# CITY OF PORTLAND, MAINE

October 29, 2015

Project Name:	Longfellow Apartments	Project ID:	2015-093
Address:	667 Congress Street	CBL:	046 C019 020
Applicant:	Redfern Properties, LLC		
Planner:	Shukria Wiar

Longfellow Apartments  
667 Congress Street  
Subdivision and Level III Site Plan  
2015-093  
Redfern Properties, LLC, Applicant

DRAWING NO.  
**SP-2**

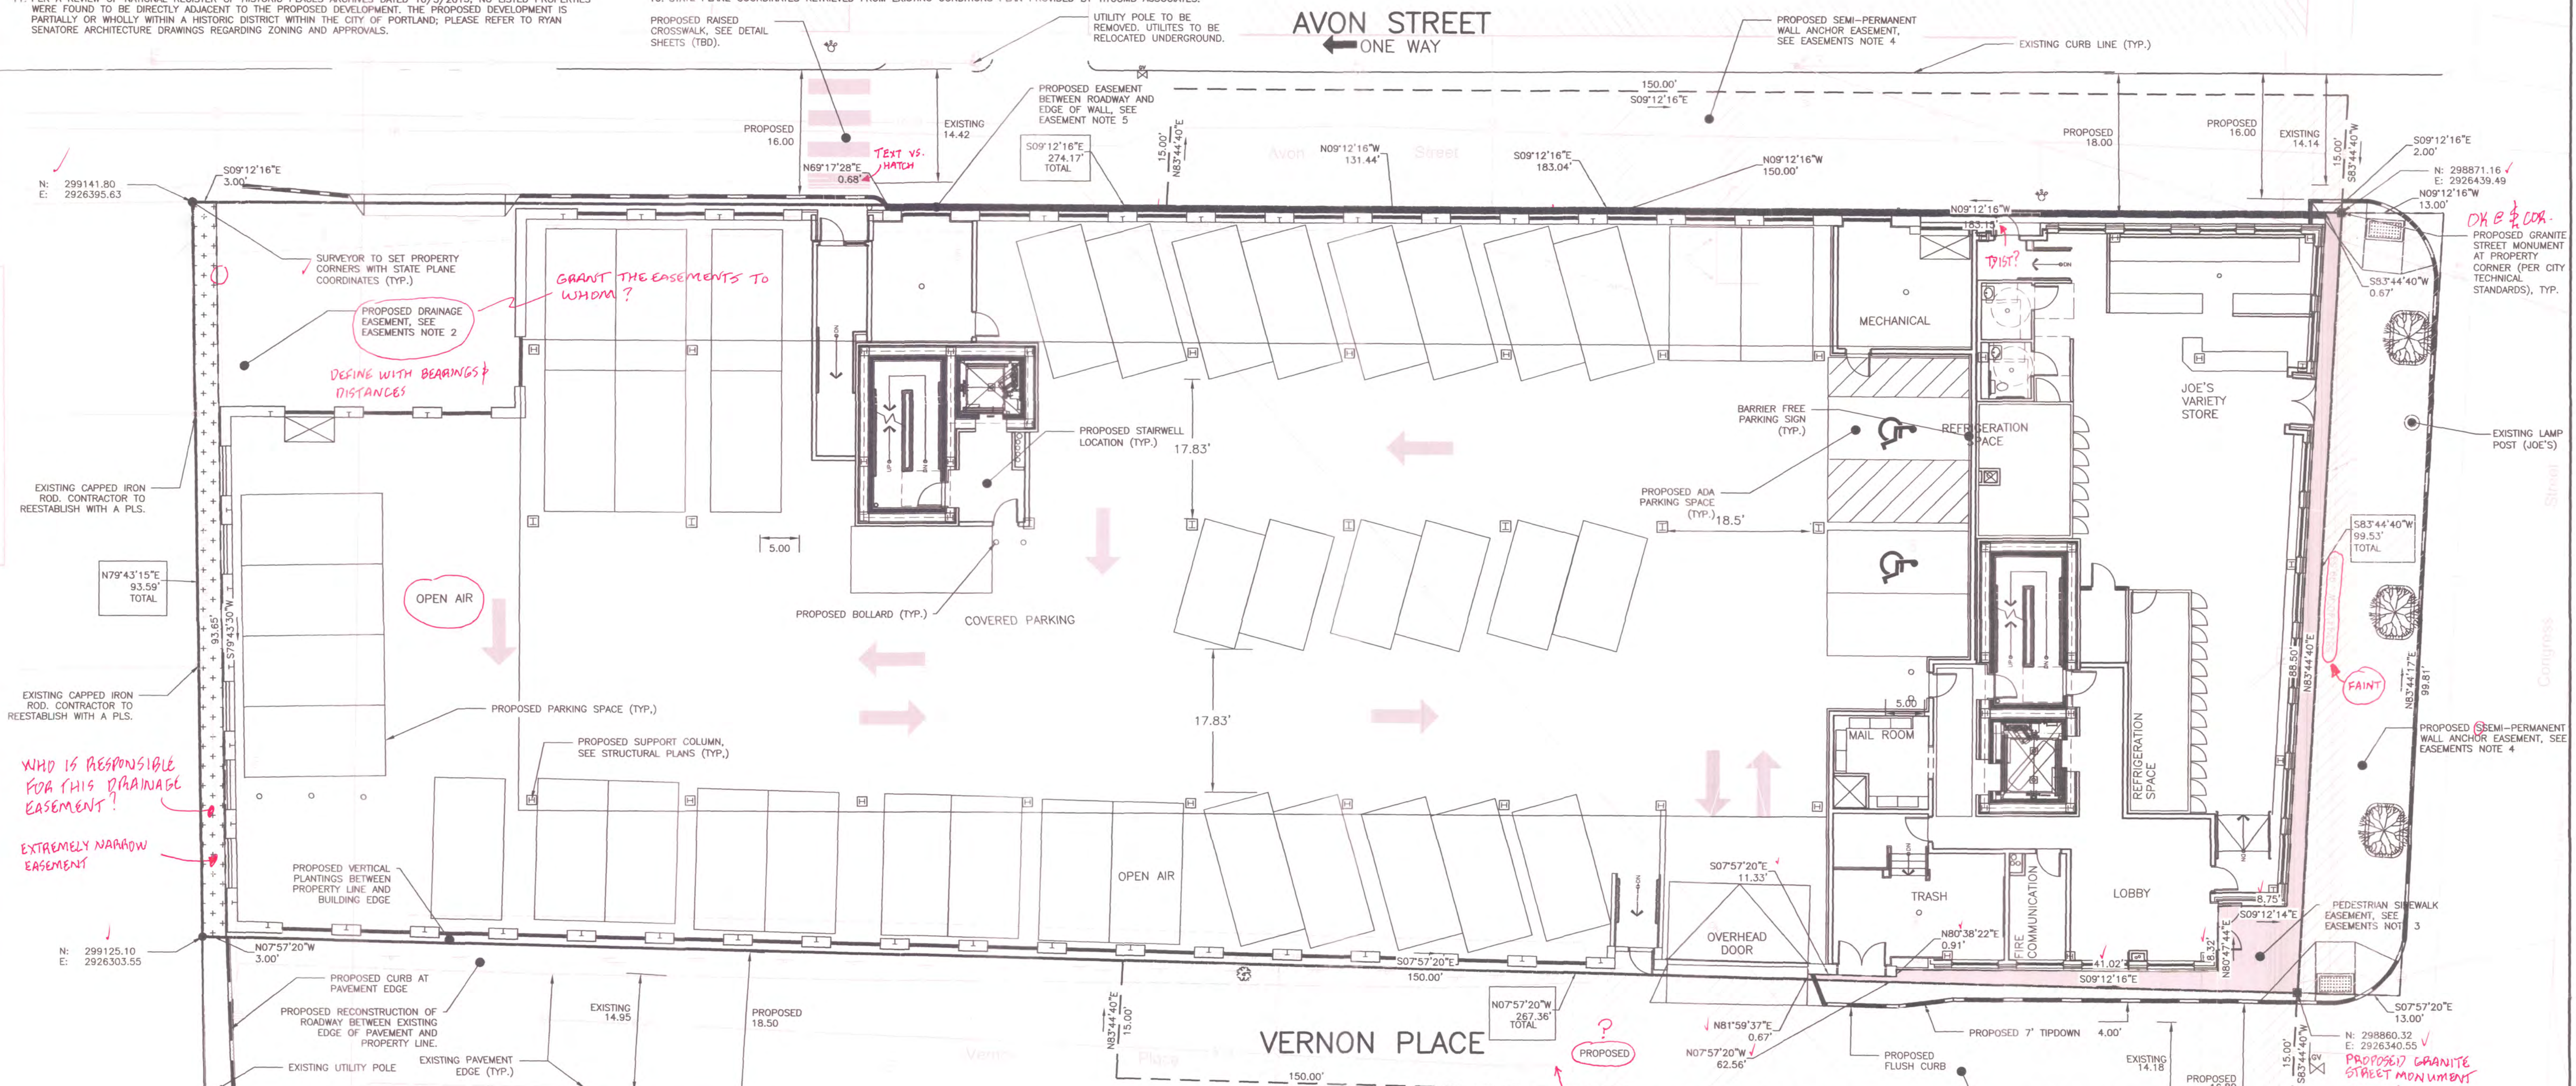
5. The City Surveyor comments dated 10.21.2015, as stated below and marked up on the plat, shall be addressed prior to the issuance of a building permit:

- c. Need to add note to subdivision plan that the City will not be responsible for the catch basin in Vernon Place and the storm drain which runs under the building.

1. Minor drafting suggestions for legibility.
2. Granite Monuments OK to set at sideline corners at Congress Street as we will be able to access them.
3. Drainage easements. Need to define who will own and be responsible for them.
4. The existing 10 foot wide Storm Drain Easement from Vernon Place to Avon Street will need to be discontinued by City Council as we will not be responsible for a storm drain or sewer which runs under a building.
5. Need to add note to subdivision plan that the City will not be responsible for the catch basin in Vernon Place and the storm drain which runs under the building.
